Access Compliance Report Public Rights-of-Way (Curb Ramps)

Main Street: CHRISTY_LN Cross Street: BRIMHALL_DR Location: NE

ADA ID: RPRK211207132243 Ramp Type: Type 1 - Perpendicular Diagonal Initial Pass/Fail: Pass Overall Compliance: No Severity Score: 10

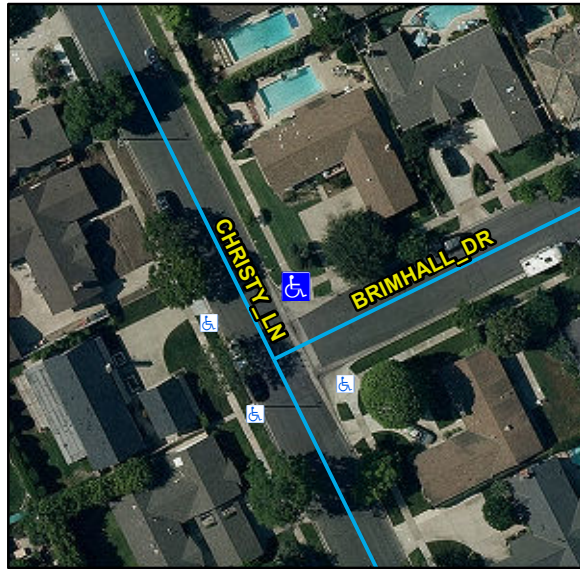
Remove & Replace Curb Ramp With Two New Directional Ramps or Equivalent. Gutter Ponding Observed.

Possible Solutions:
